QUESTIONS ON WATERFORD 3 BASEMAT
3/26 MEETING IN BETHESDA

Allegations recently reported in a GAMBIT newspaper article and in staff investigations concerning the GAMBIT article have lead to the assignment of additional reviewers to evaluate the base mat adequacy. This transmittal is a composite set of Questions from the reviewers, and is intended to faciliate LP&L's preparation for the meeting on March 26, 1984 in Bethesda.

DIFFERENTIAL SETTLEMENT CONTOURS

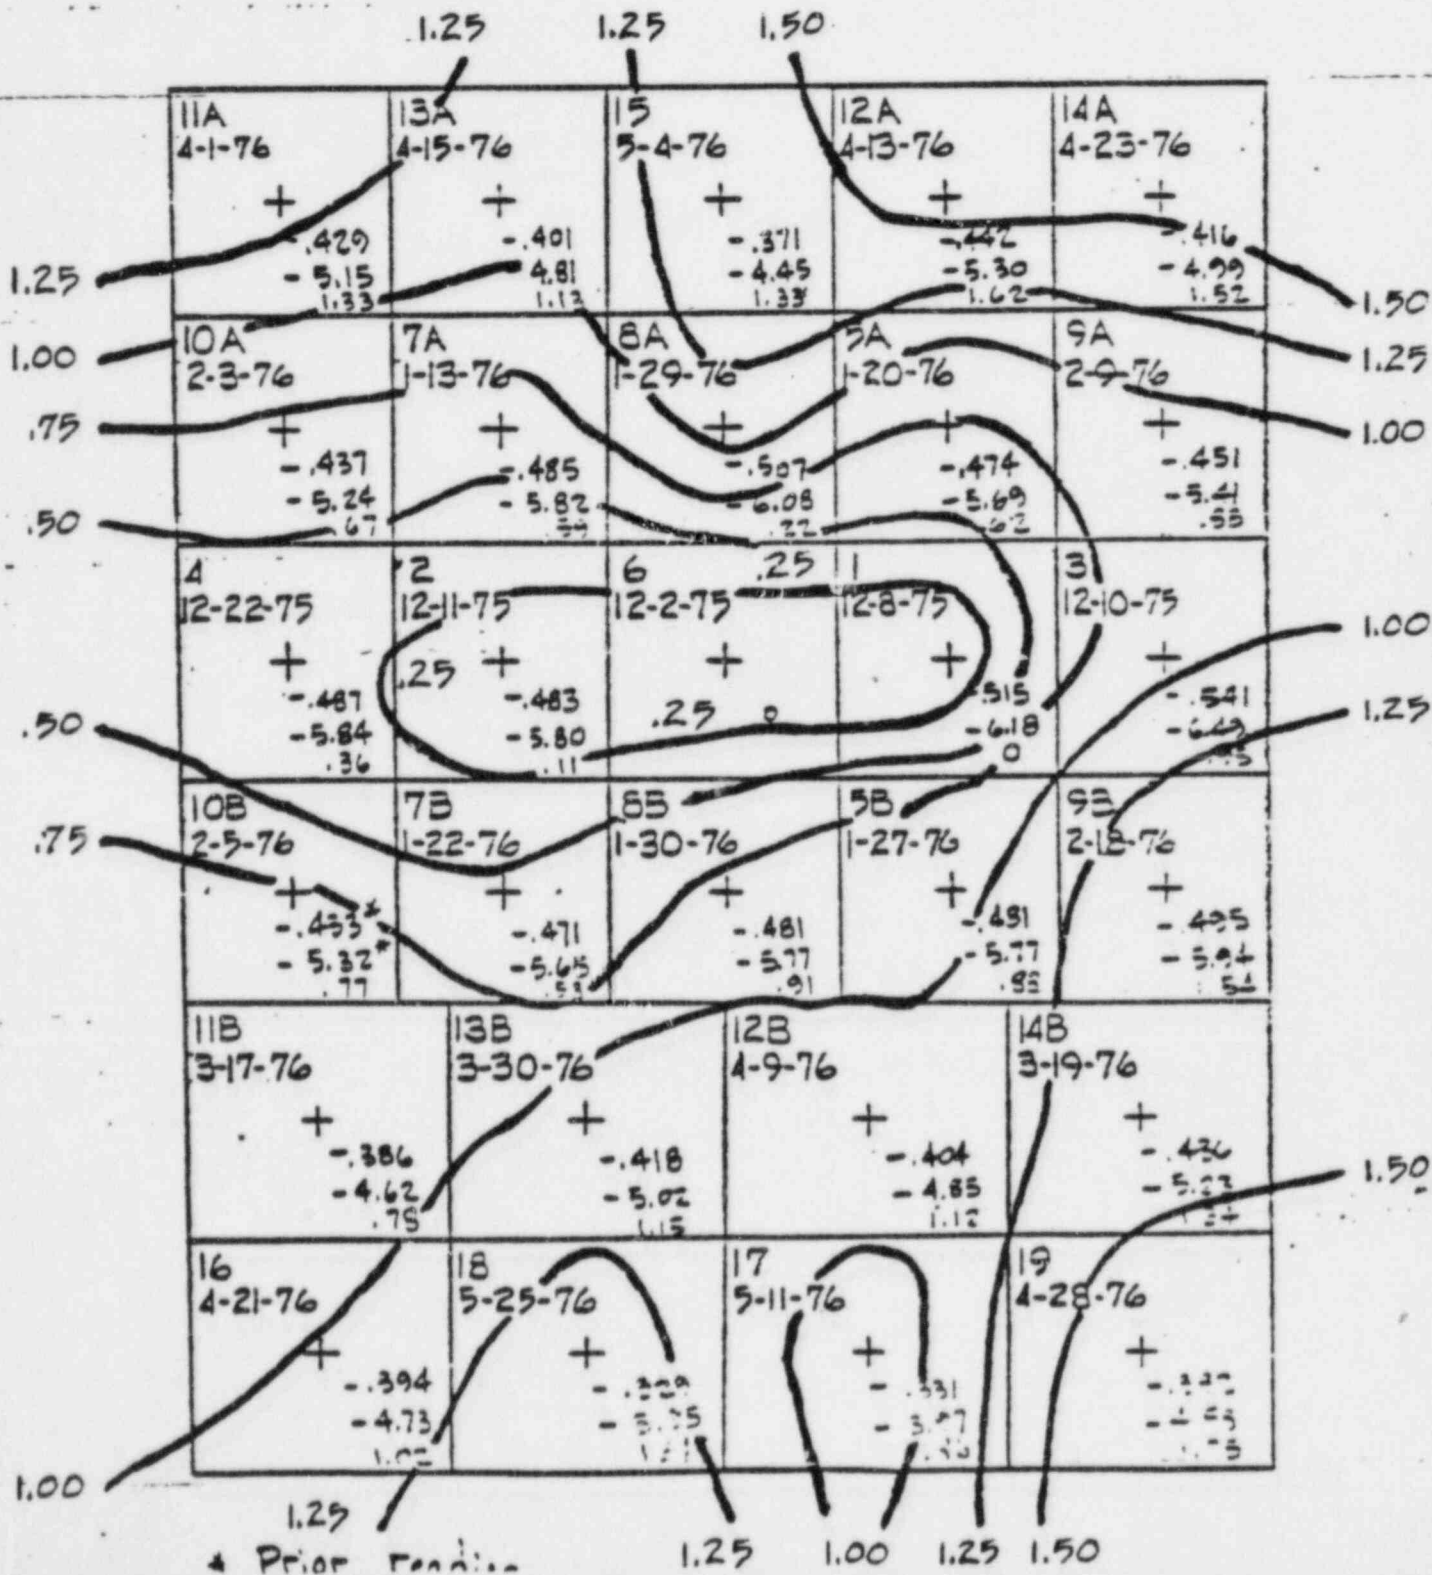
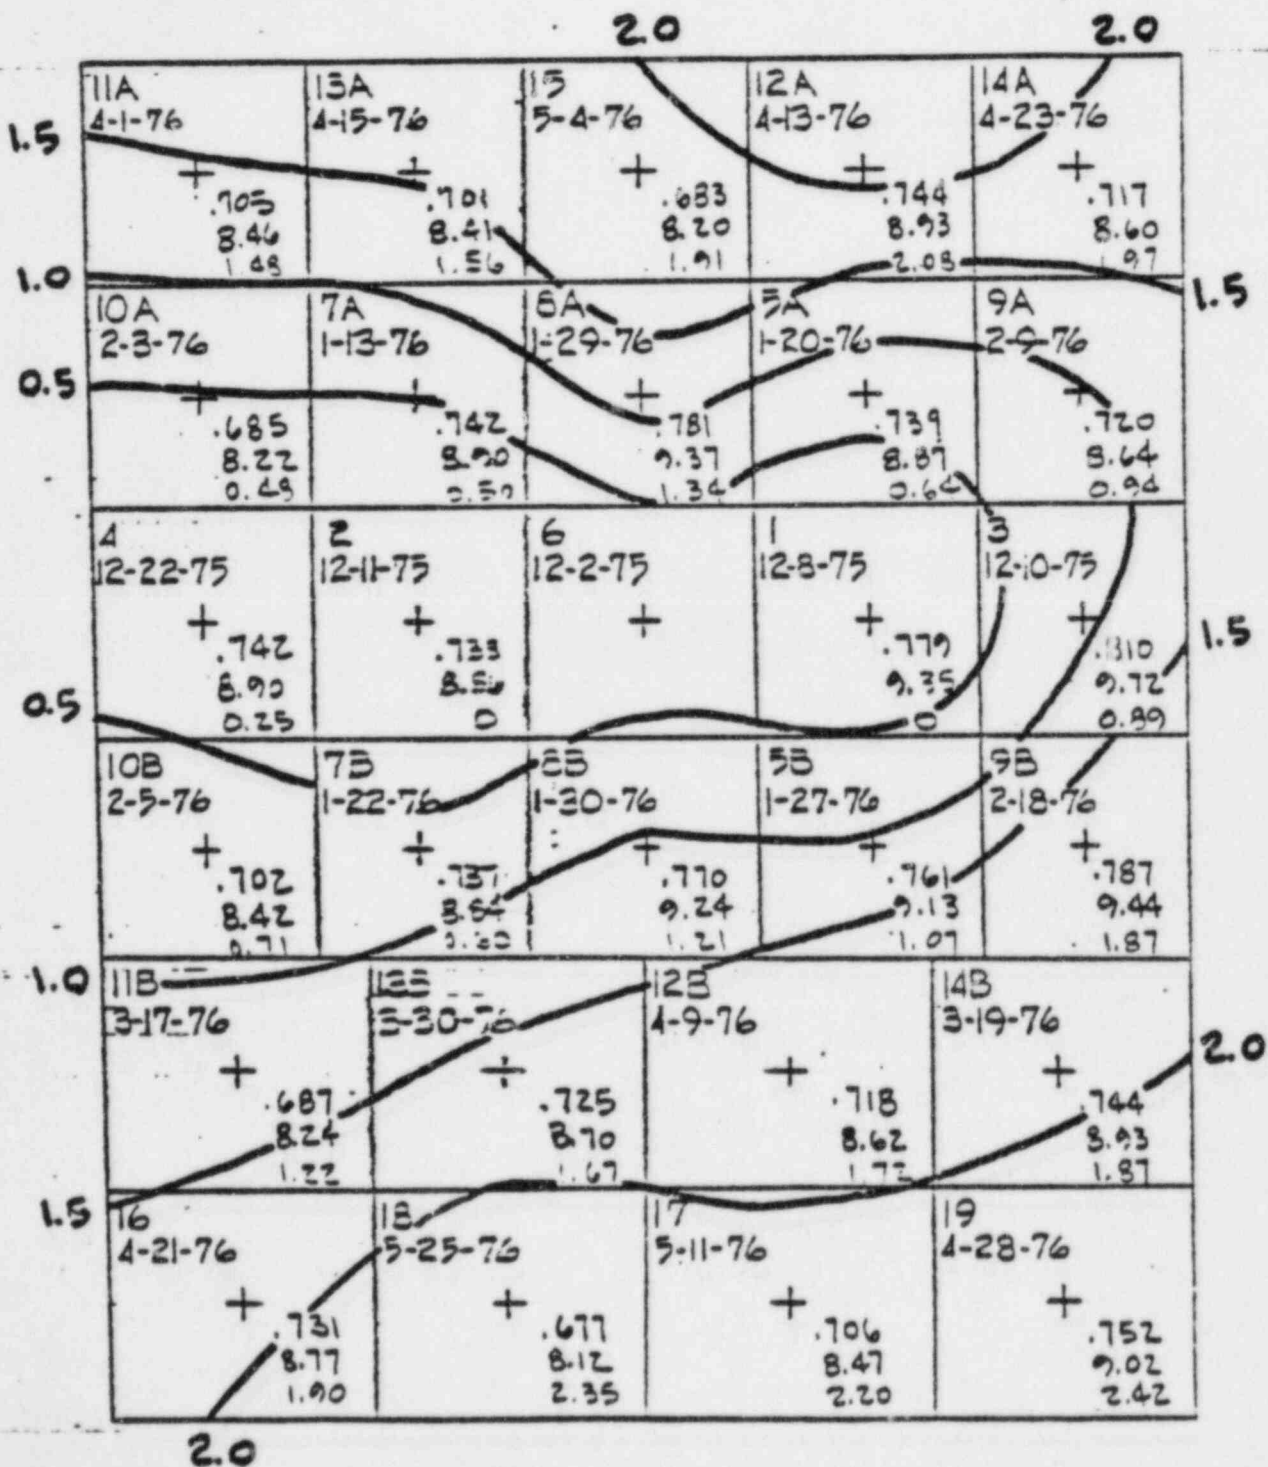
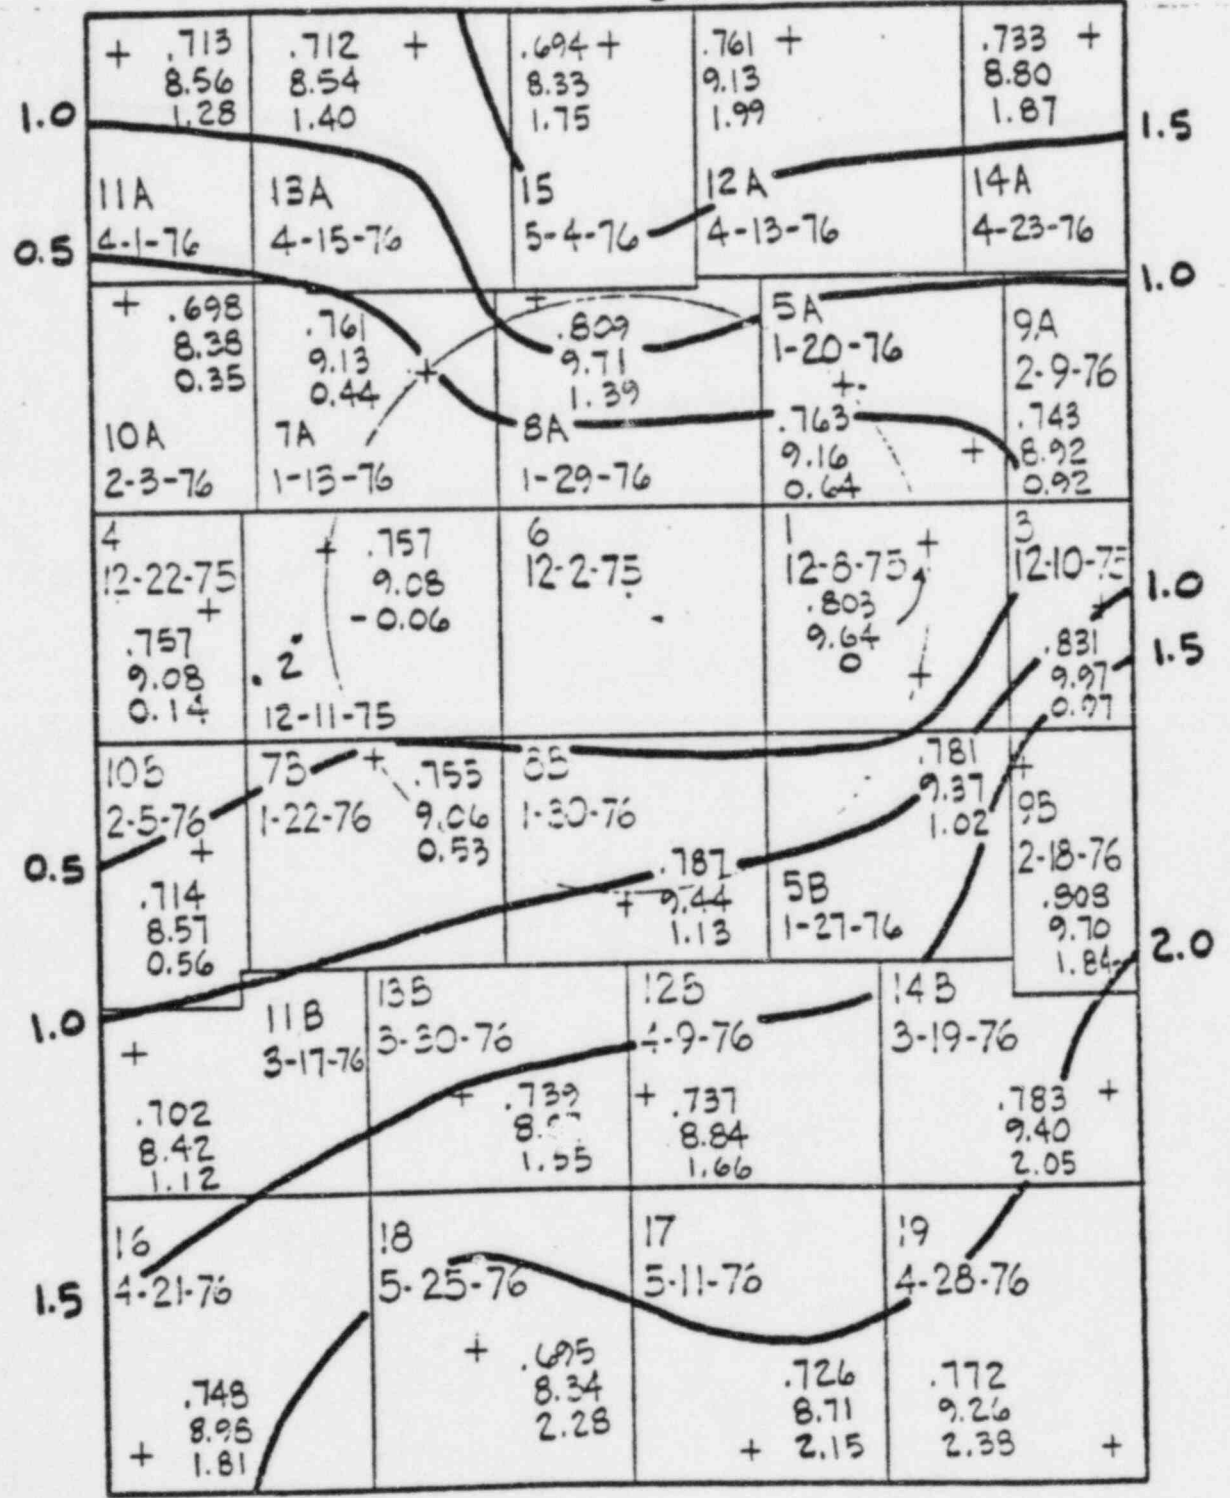
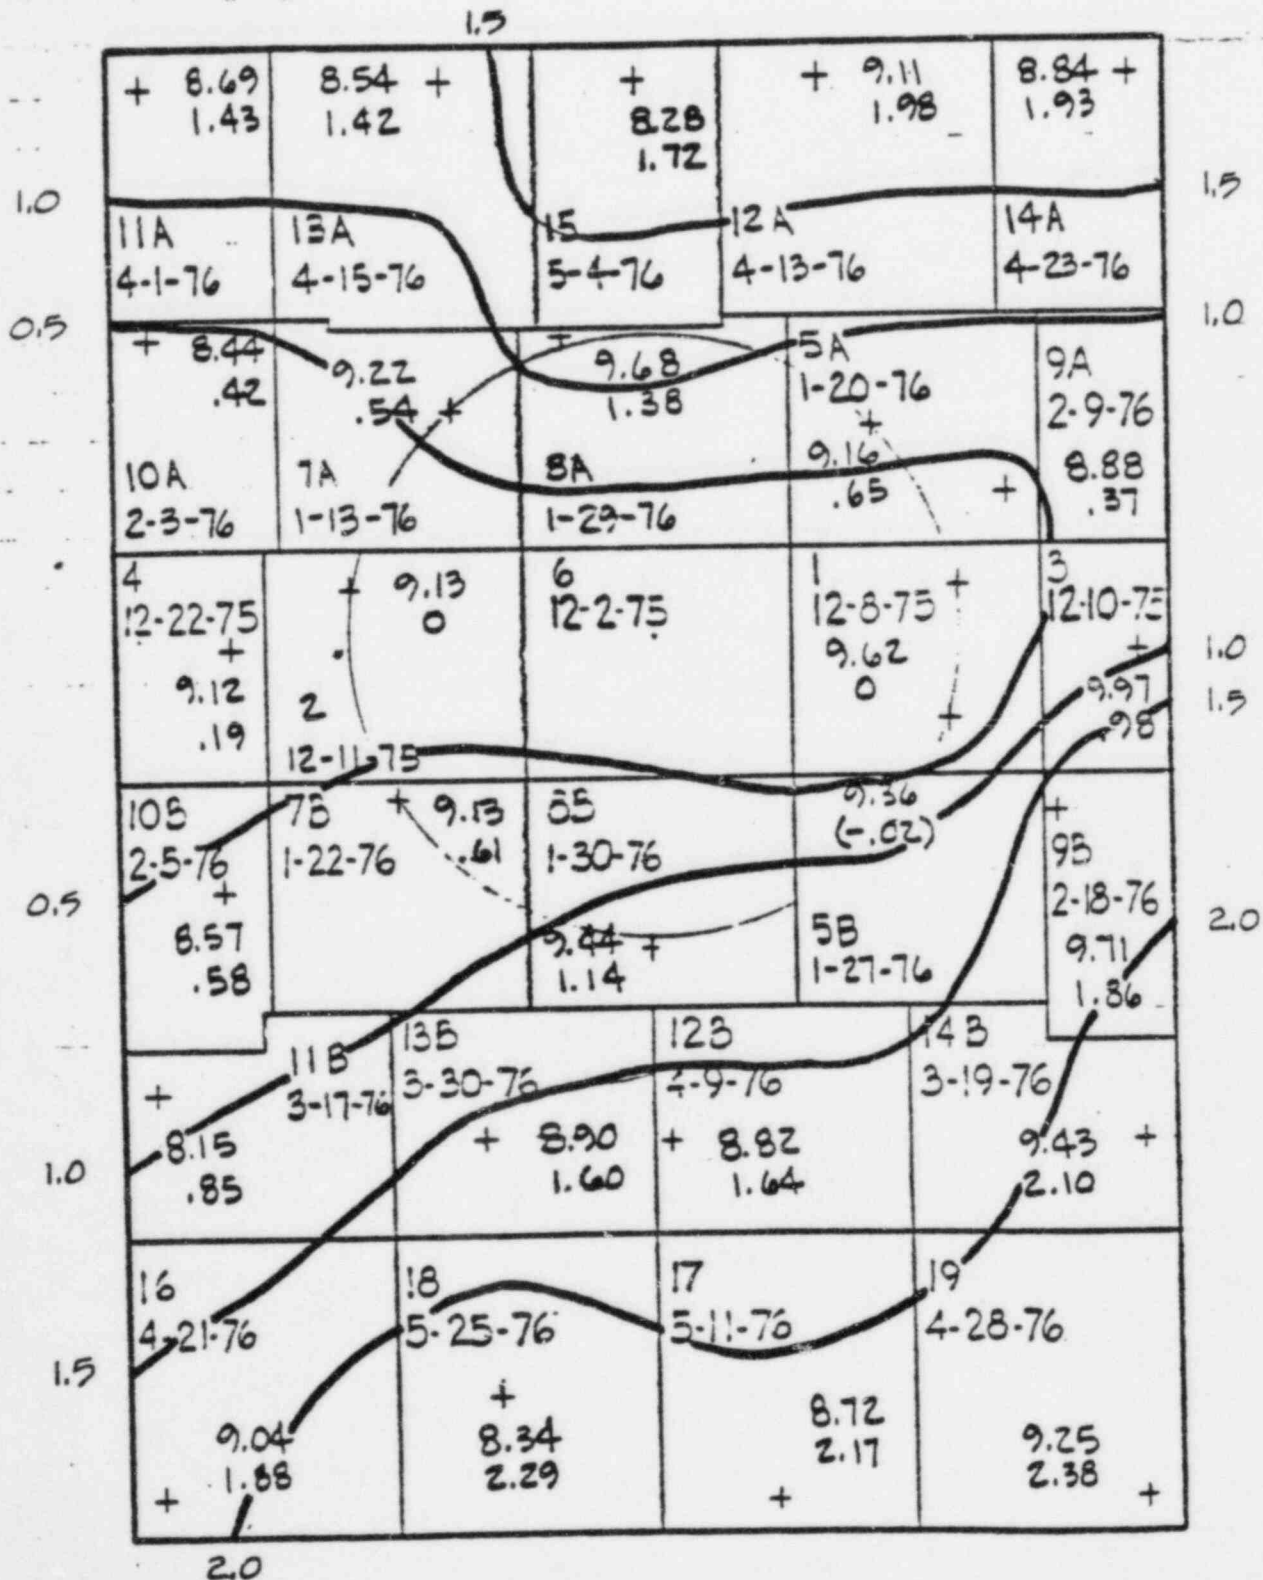
17. Provide differential settlement contours for 6 month periods, starting from early 1977 to present.

Response:
